# Access Compliance Report

## Public Rights-of-Way

### (Curb Ramps)

Intersection ID: 12425	Main Street: W_MOREHEAD_ST	Cross Street: ELDRIDGE_ST	Location: NE
ADA ID: 77A004453DB7	Ramp Type: PerpDiag	Initial Pass/Fail: Fail	Overall Compliance: No
Codes/Mitigation Info/Possible Solution		Field Measurements/Component Compliance	
Severity Score: 12.5

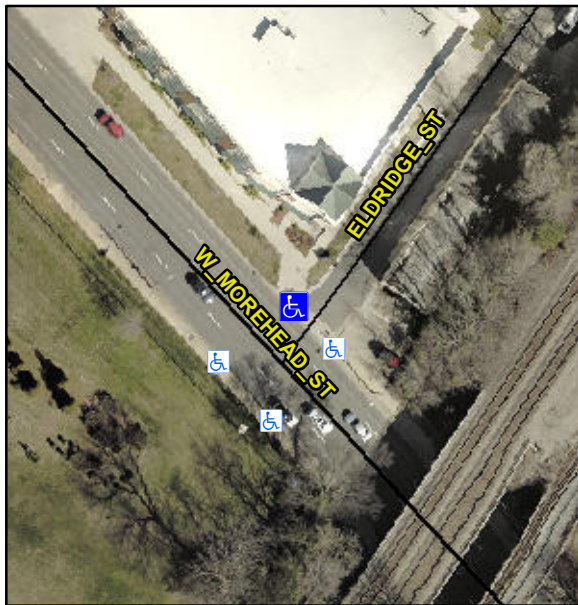
**Not Found, R304.2.2**

**Remove & Replace Curb Ramp With Two New Directional Ramps or Equivalent.**
